# City of Sandy

### Planning Commission Meeting

**Meeting Date:** Monday, April 22, 2019

L20

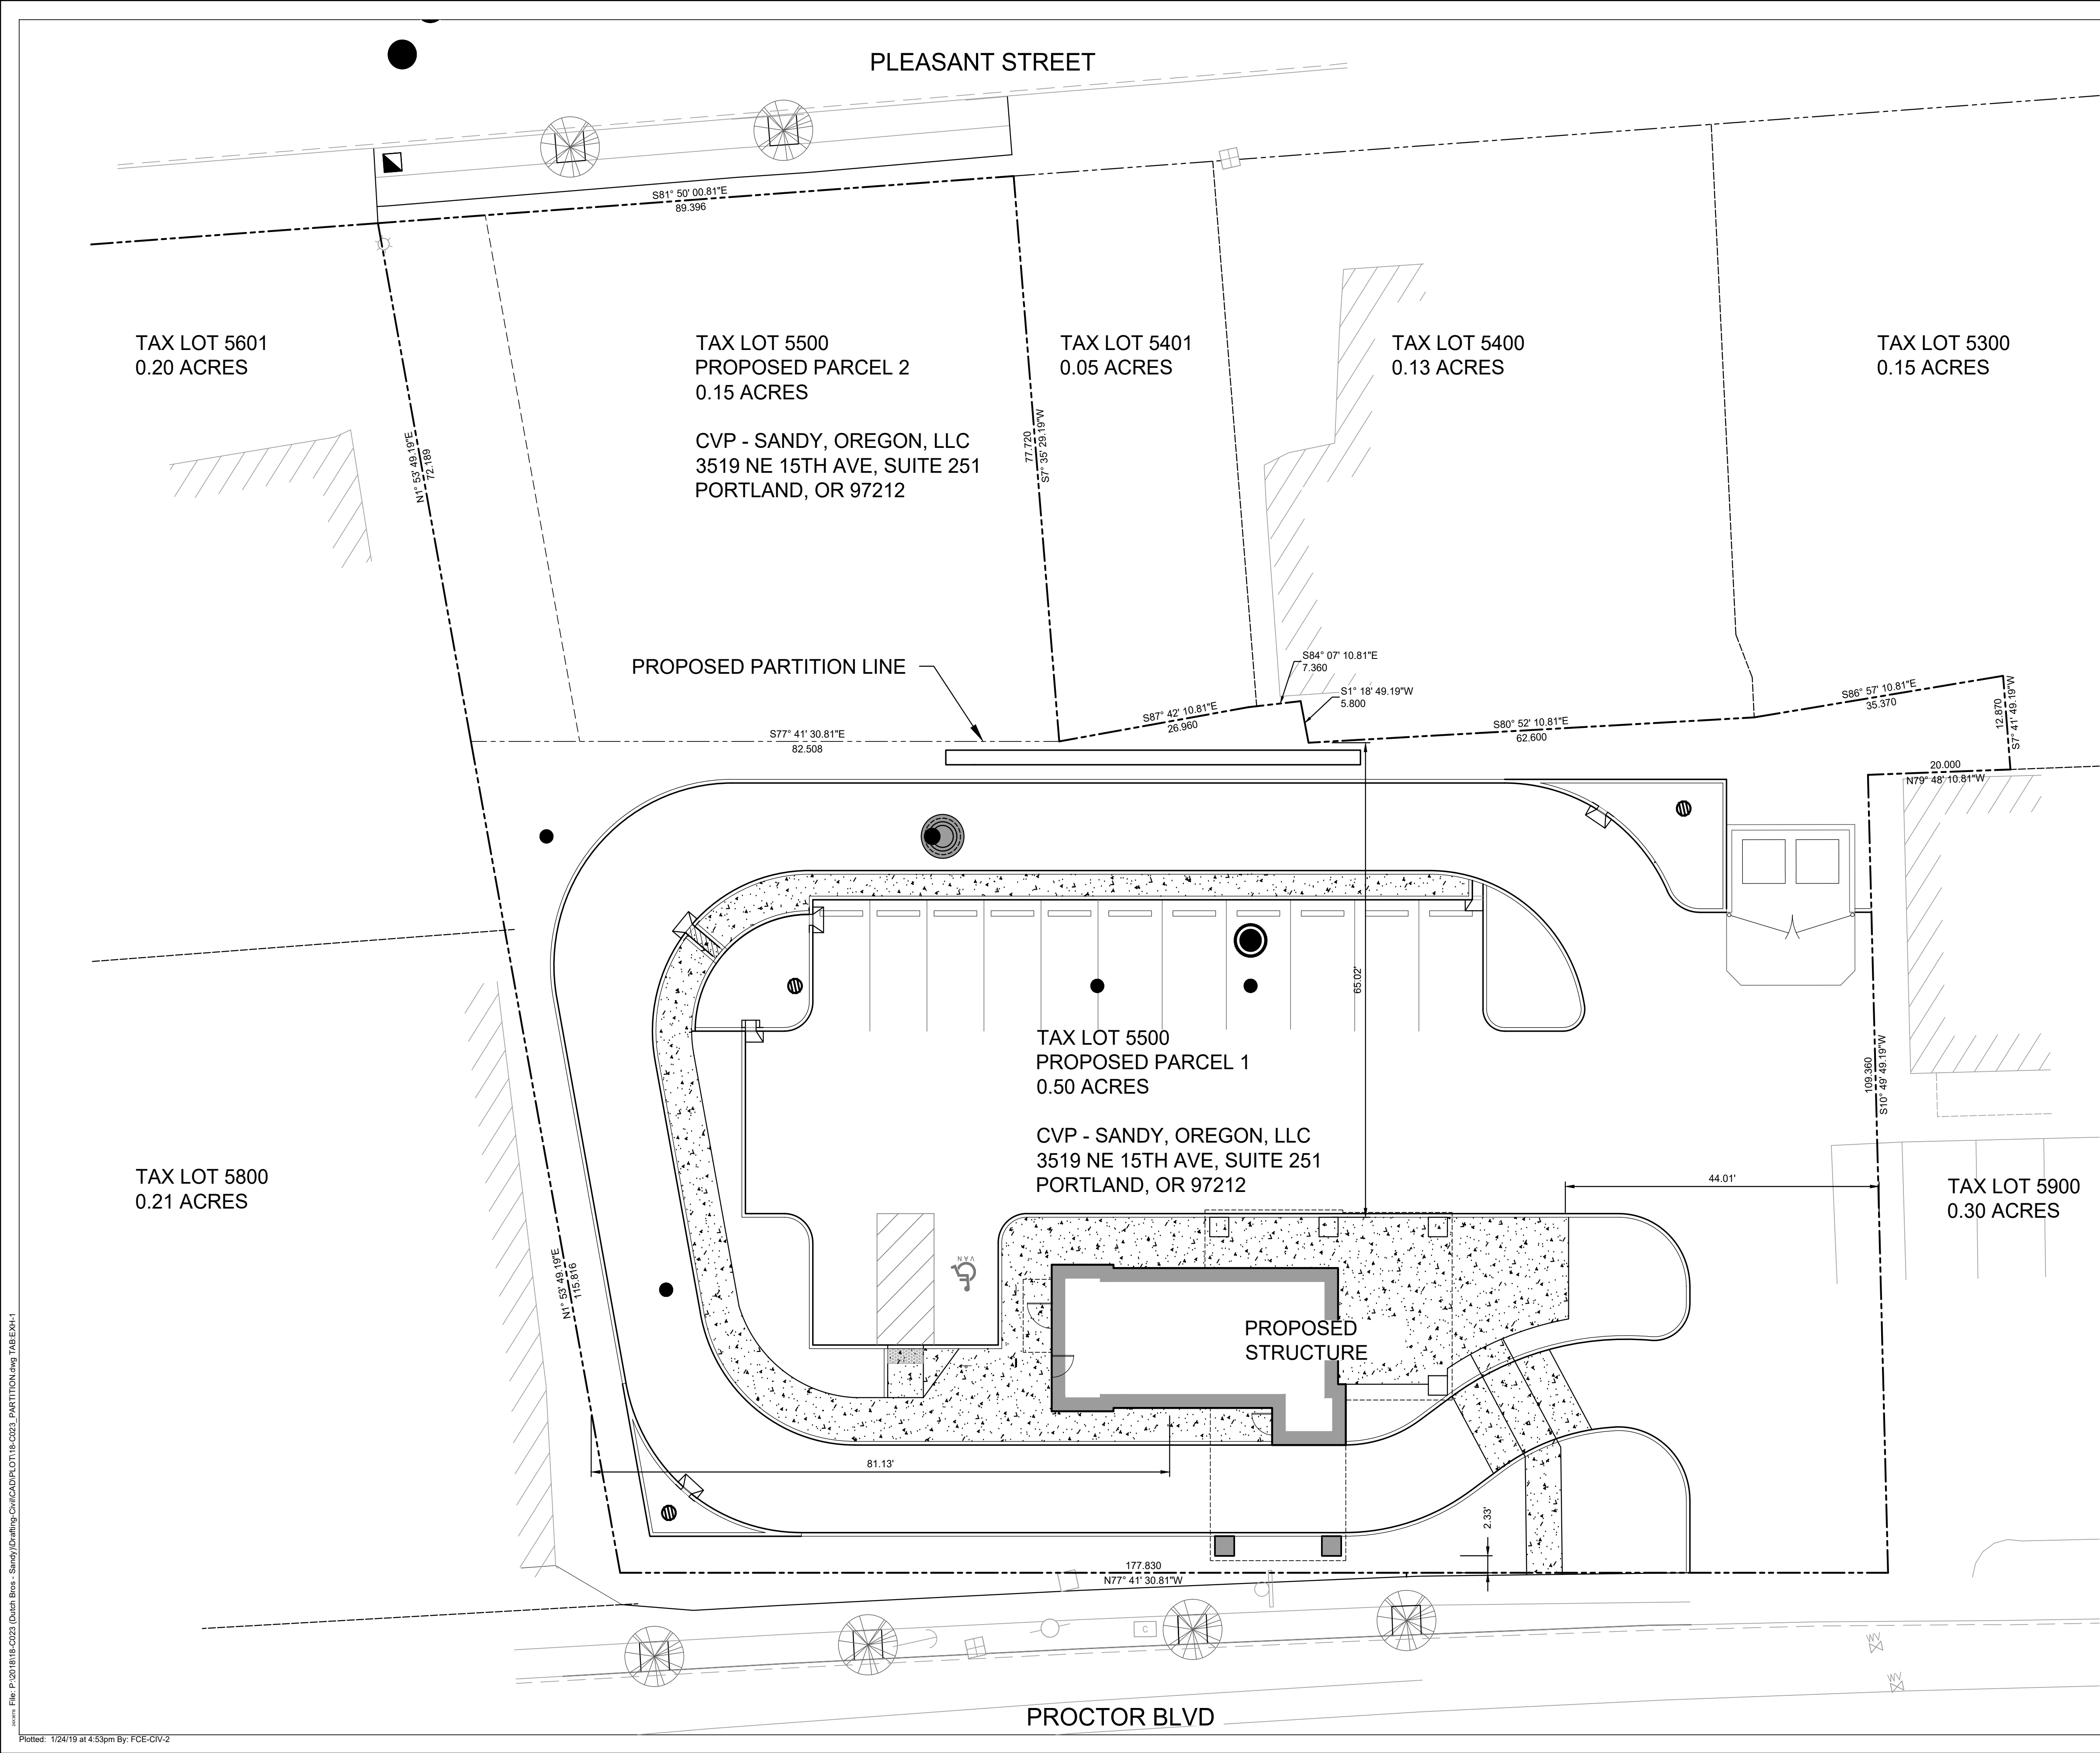
**RESPONSE:** *The applicant has submitted landscaping plans (Exhibit I, Sheet L10 & L11) with an associated detail sheet for additional planting information (Exhibit I, Sheet L20). The proposal includes a Type I Land Division (Minor Partition) request to subdivide the existing parcel into two lots (PPI and PPII). PPI is to be redeveloped with an eating and drinking establishment and proposed drive-through facility while PPII is to remain vacant for future development. While PPI is currently absent of trees, PPII has trees located within the proposed boundaries, therefore **the applicant shall install tree protection fencing located 5 feet outside of the dripline of all existing trees on site. Per Section 17.92.10(L), all landscaping shall be continually maintained, including necessary watering, weeding, pruning, and replacing.***

**COMMENT: All plant materials indicated on plant schedules on sheets L11 and L20 are native or adaptive plant species.**

**COMMENT: All proposed plants comply with this standard. See plant schedule on sheet L20.**
